CITY OF ALBUQUERQUE

Re: Sandia High School Science/Math Classroom Building Library
7801 Candelaria Rd NE
Engineer's Stamp dated: 77/27/2012 (G19D021)
Certification dated: 9-23-14

**Re: Sandia High School Campus-Wide Drainage Improvements Overall Grading
and Drainage Plan**

SANDIA HIGH SCHOOL CAMPUS-WIDE DRAINAGE IMPROVEMENTS Albuquerque, New Mexico

Typical SO #19

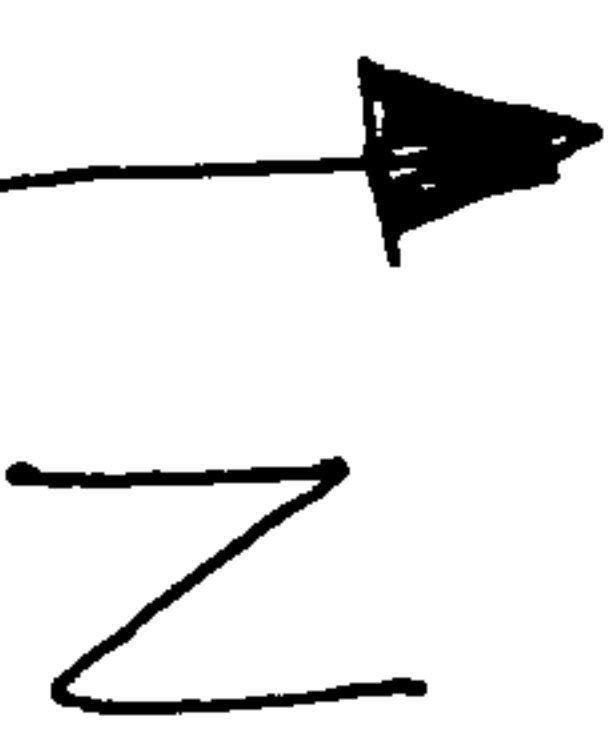
QUESTION: WORK ORDER OR SO #19?

PIPE / PENETRATION WOULD NOT

MADE ONLY

PRIVATE FLOW LIKE
